RE: Closure Report for the Rincon Lateral CDP #2 Site

CLOSURE REPORT

CHEVRON NORTH AMERICA'S
RINCON LATERAL CDP #2
DISCHARGE PLAN PERMIT GW-070
SECTION 1, TOWNSHIP 26N, RNG 7W,
RIO ARRIBA COUNTY, NEW MEXICO

Response to NMOCD Inspection Report (May 7, 2008)
Chevron Lateral #2 Compressor Station, GW – 070
September 19, 2008

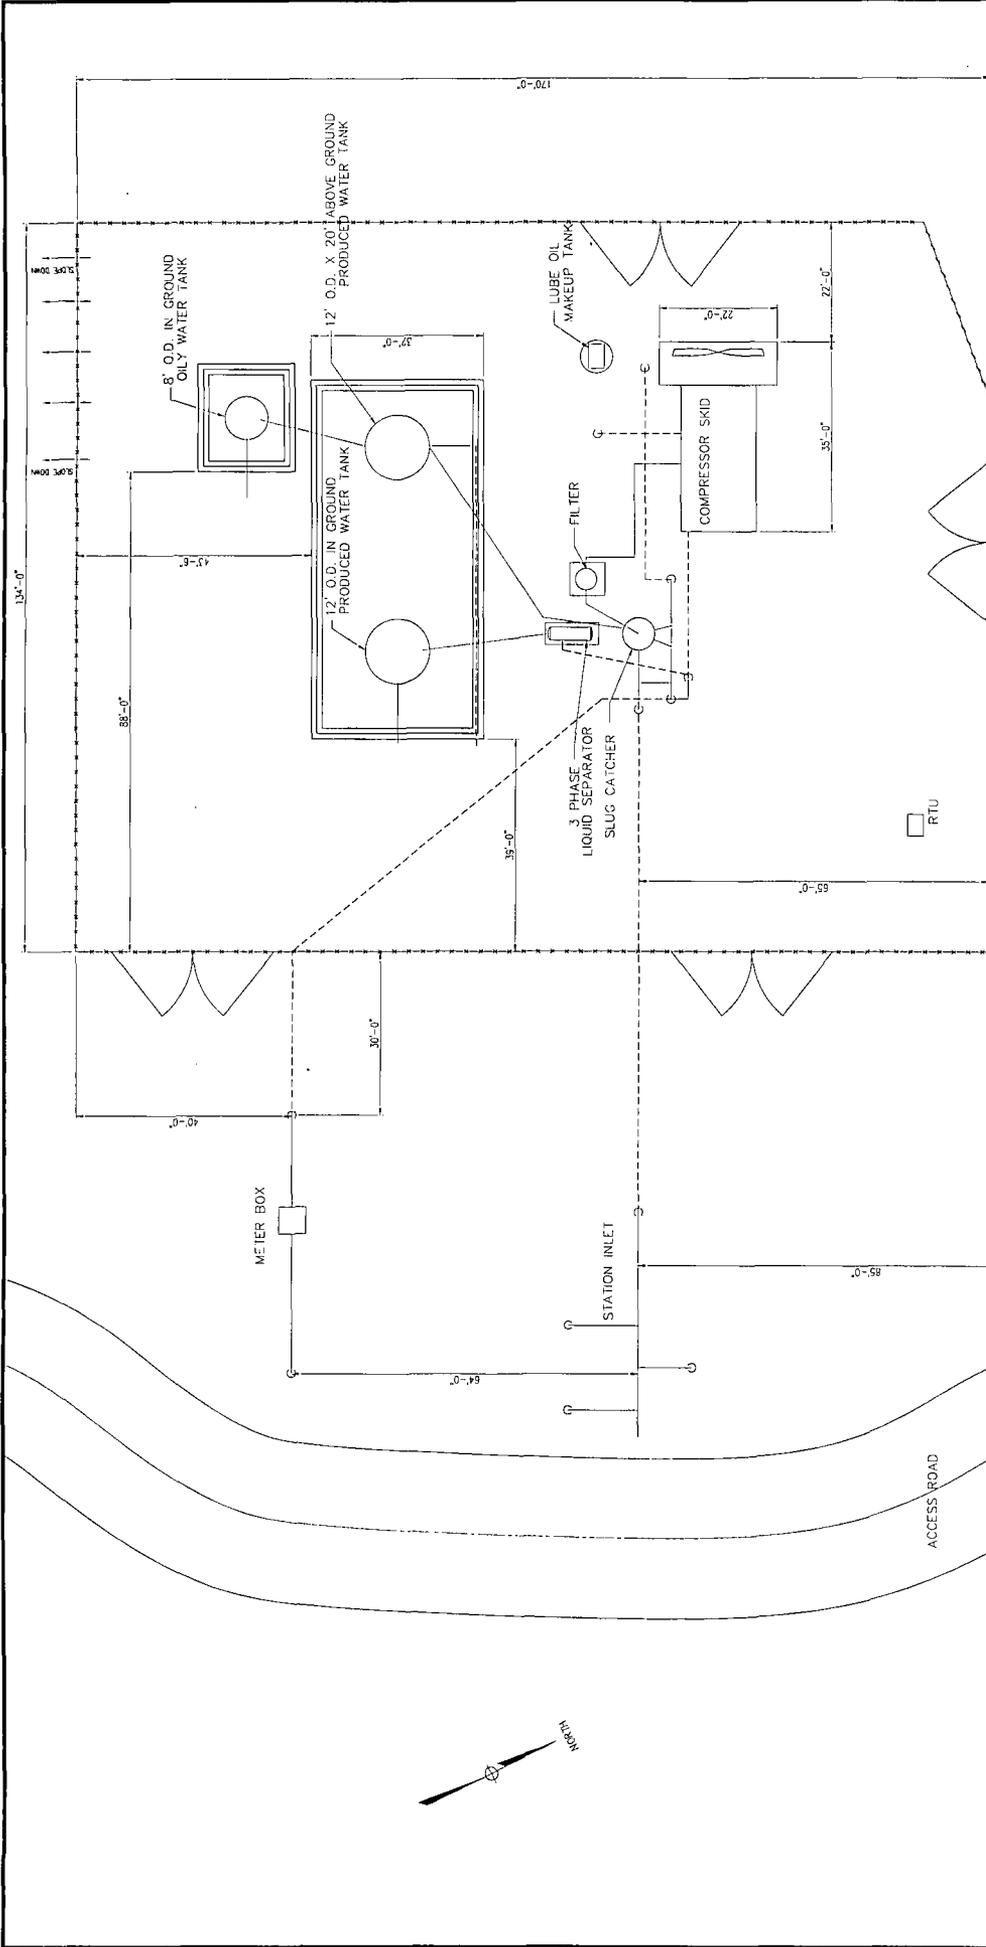
Finding	Description Inspection Report (May 7, 2008)	Action
1.	<i>Site facility sign denotes incorrect Discharge Plan number; it should be GW-070. Chevron has 3 months to correct this.</i>	Photo 1: The sign has been updated with the correct Discharge Permit number.
2.	<i>Lines flowing in to this BGT can not be identified. Chevron has 3 months identify these lines and annotate in on their facility schematic and submit to the OCD.</i>	Photo 2: BGT has been removed. Facility schematic was updated and submitted in August 2008 with proposed modifications of below grade tanks on site.
3.	<i>The leak detection of BGT has fluids. Chevron shall verify</i>	Photo 2: The BGT has been

6.	<i>Berm the facility to decrease run on and off of water. This will prevent erosion; the possibility of any spills or releases from going off site and creating excess waste from run on commingling with liquids on site.</i>	The facility will be bermed upon completion of the Lateral 2 compressor modification project. Photos will be provided. ✓

Photo 1: Facility sign has correct discharge number.

Photo 4: Area has been cleaned.

Photo 2: BGT has been removed.

Photo 5: Cap for leak detection system has been installed.

Photo 3: Area has been cleaned.

CHEVRON NORTH AMERICA
EXPLORATION AND PRODUCTION
CHEVRON RINGCON LATERAL #2 CDP
SITE PLAN

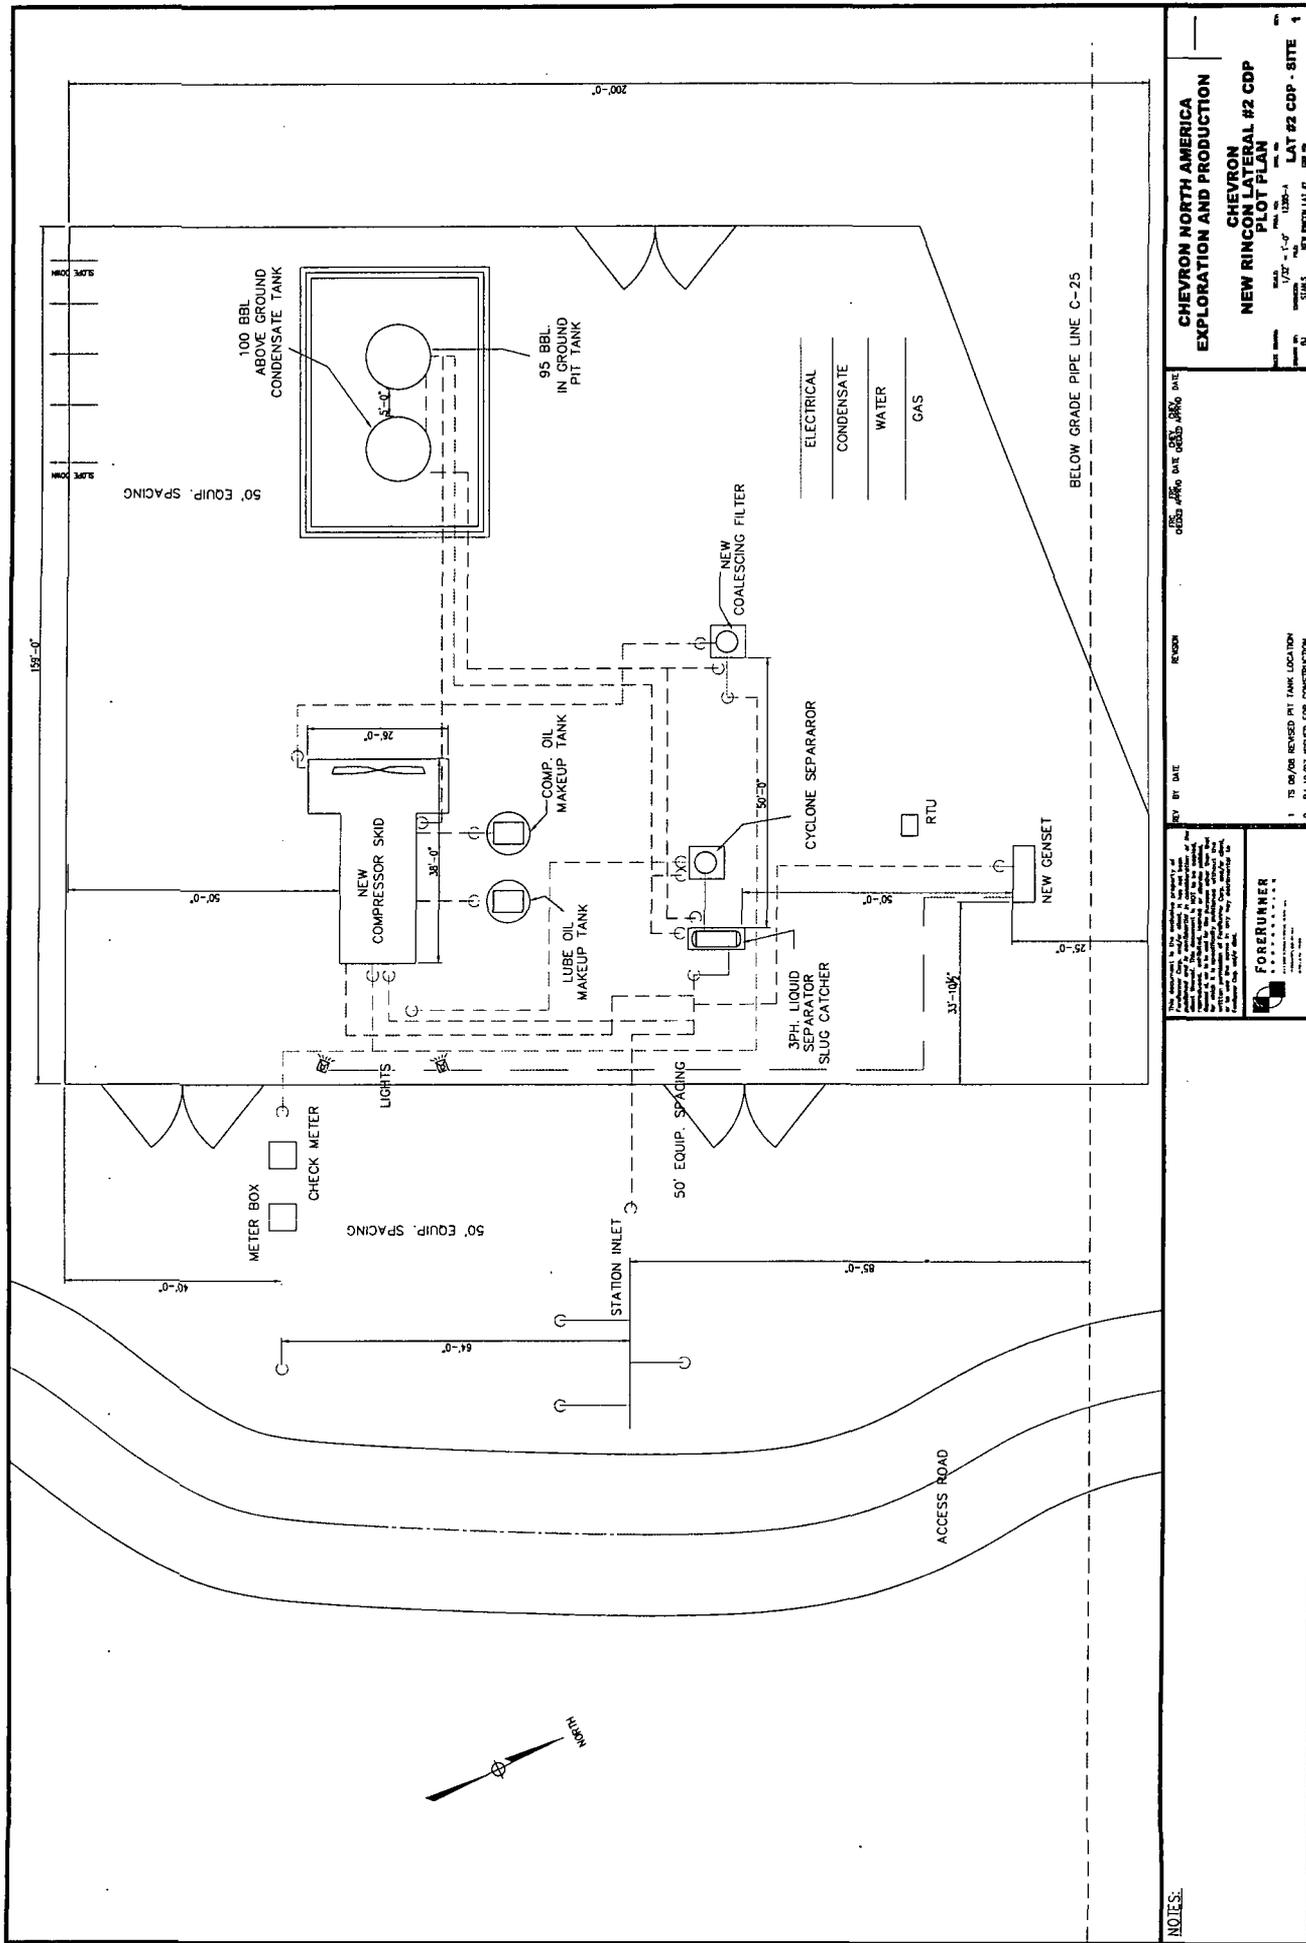
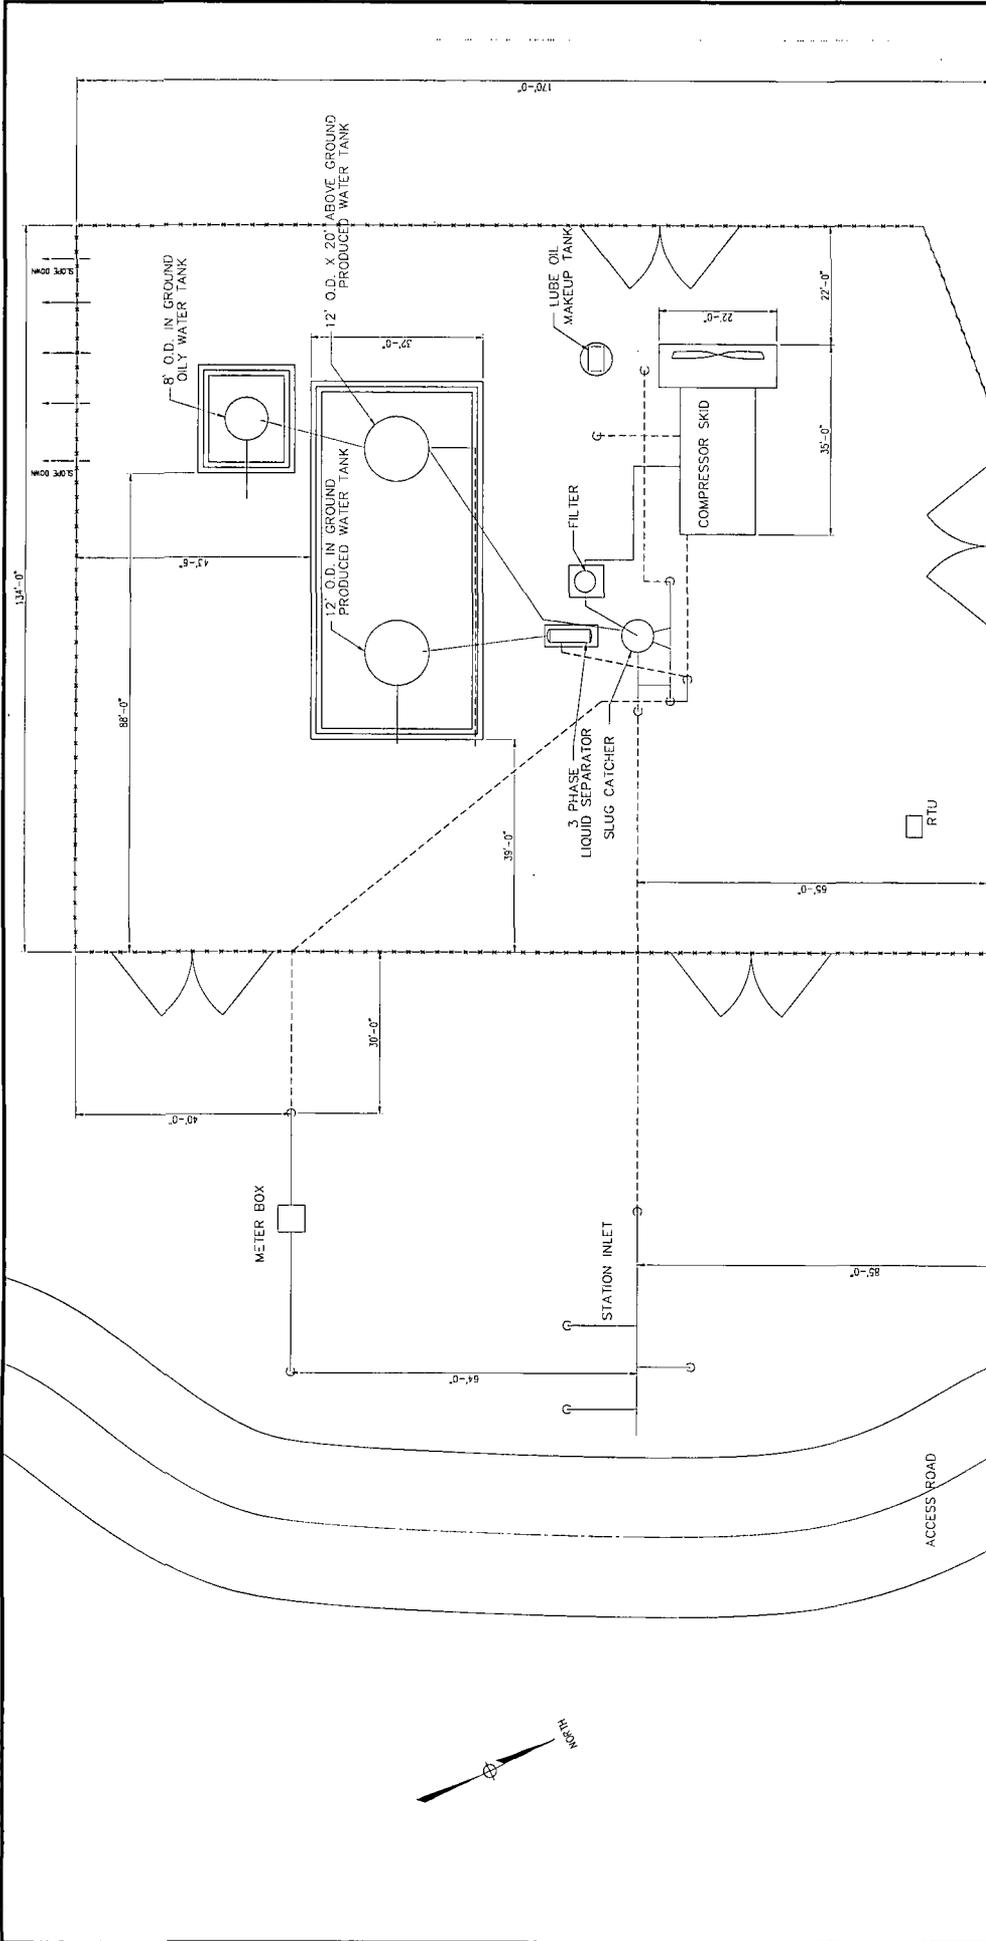
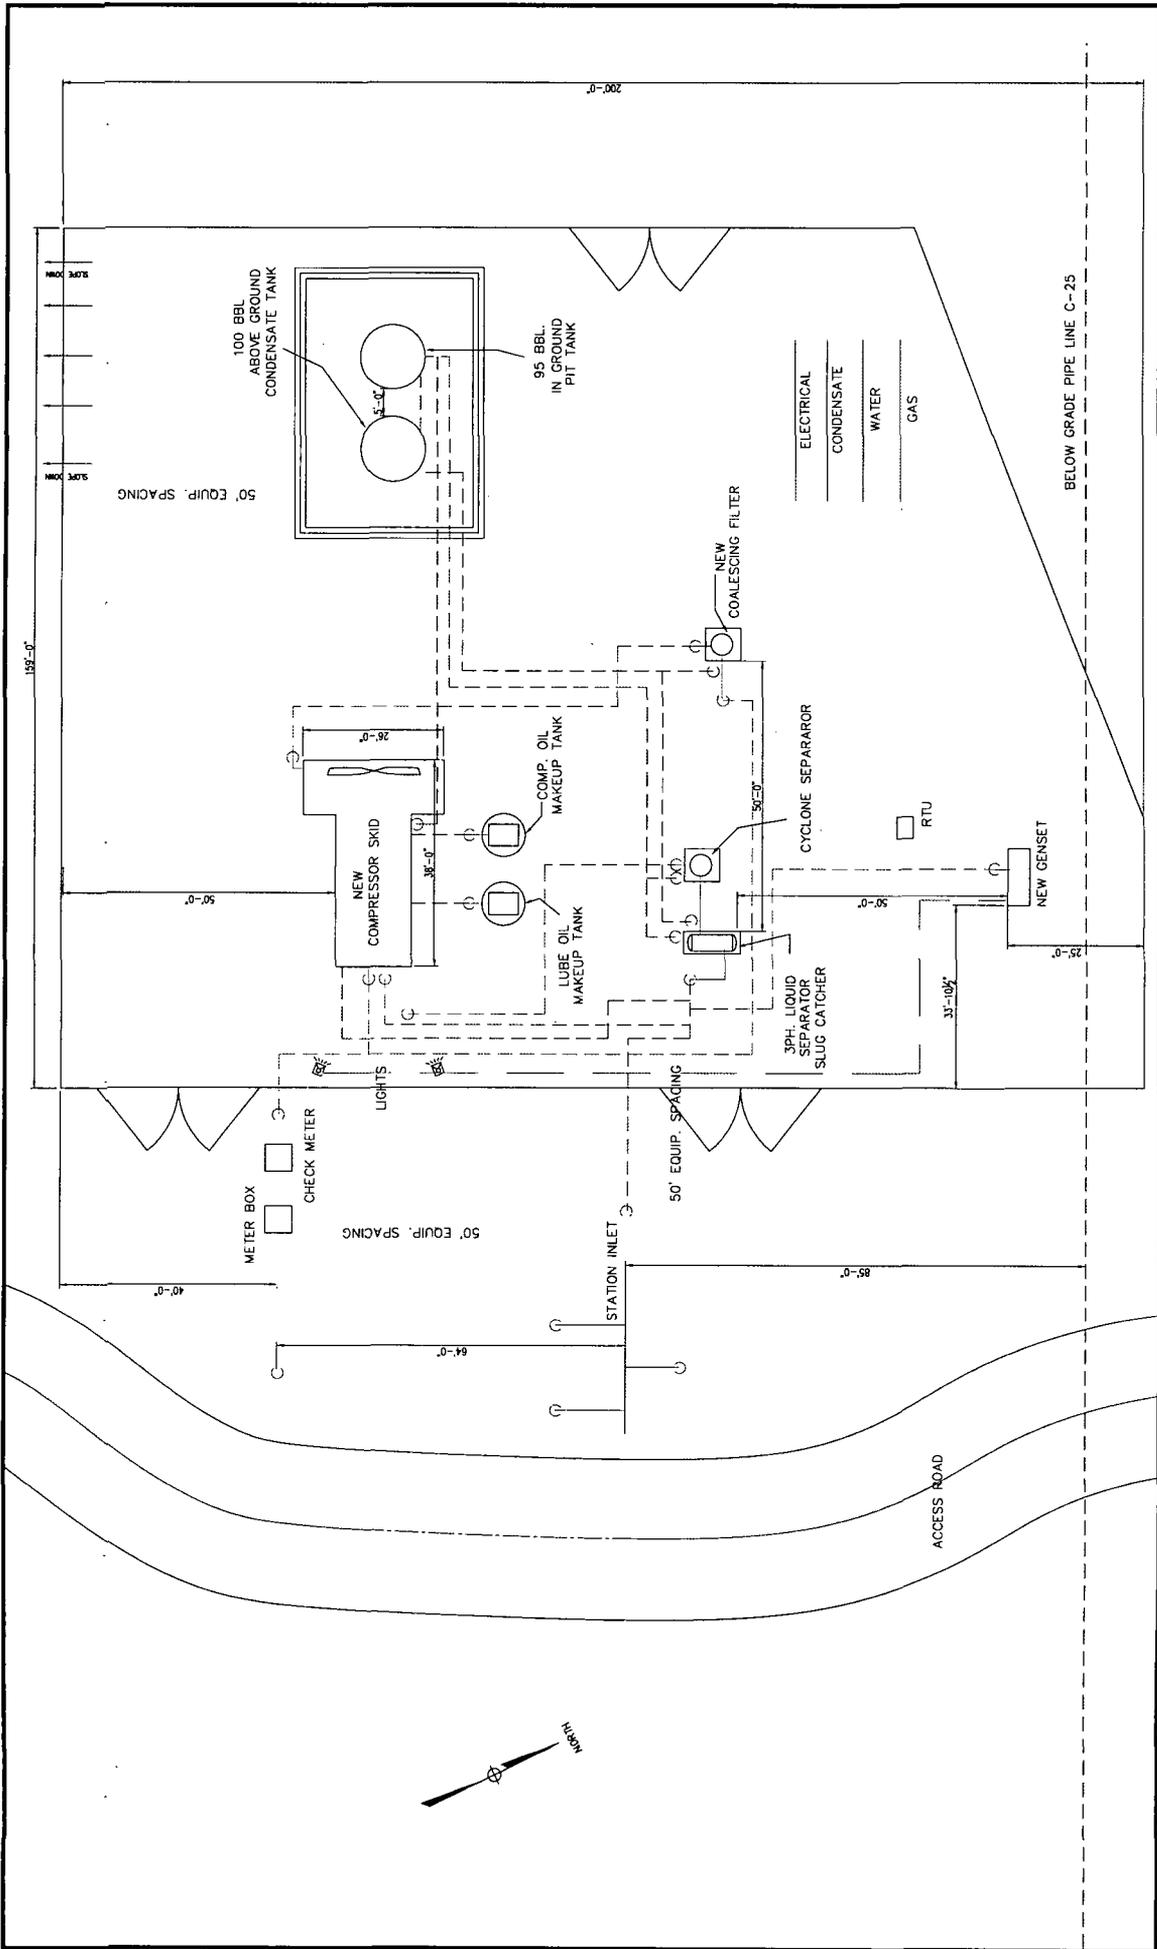
I have a few questions:

1. What is the new BGT material composed of?
2. Your letter stated a 95 BBL BGT to be removed. Your current schematic does not identify a 95 BBL BGT, but only two "in ground" tanks (oily water and produced water), therefore which of these two tanks is the 95 BBL tank to be removed? According to your "after modification" schematic, both tanks are gone, what happened? I just

1. The new BGT is composed of carbon steel and has an open top. A metal grating will be installed across the tank opening pursuant to Discharge Permit Approval Conditions 11.C.
2. I apologize for the confusion. There are actually two items to note on Lateral #2 site location.
 - 1 The "12' O.D. IN GROUND PRODUCED WATER TANK" shown on Figure 1 GW-070 Existing Lateral #2 Site Plan will be moved (not removed) to the new location designated as "95 BBL IN GROUND PIT TANK" on Figure 2 GW-070 Proposed Lateral #2 Site Plan.
 - 1 And the "8' O.D. IN GROUND OILY WATER TANK " shown on Figure 1 is an error. It has been removed. Initial soil sampling of the BGT site has been conducted.
3. The total horsepower will be 630 which is less than our current total of 900 HP.

In an effort to increase the reliability and efficiency of our operations at the compressor station, we are replacing the current rental compressor with a new compressor owned by Chevron. As part of this effort we will be removing the ninety-five barrel below ground tank currently located in the area shown on Figure 1 GW-070 Existing Lateral #2 Site Plan to the new location shown on Figure 2 GW-070 Proposed Lateral #2 Site Plan according to the tank specifications shown on Figure 3 Standard Below Ground Tank.

Photo 3: BGT leak detection system is full of fluids.

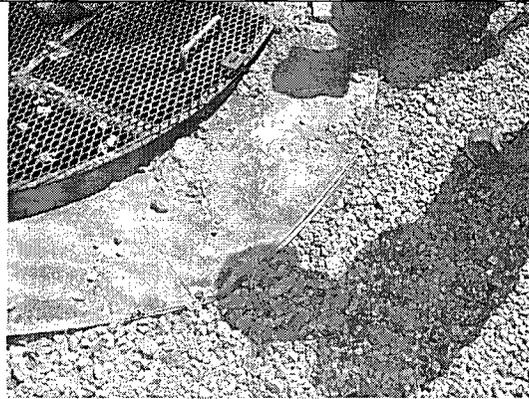
3. Photo 3 & 4: The leak detection of BGT has fluids. Chevron shall verify the integrity of the tank. The top of the tank is not adhered to its side wall causing access to its leak detection from external sources. Construct this tank to prevent run off to enter its leak detection system. If the tank has leaked in to the ground Chevron shall submit to the OCD a course of action to resolve this concern. Chevron has **3 months** to address this concern.
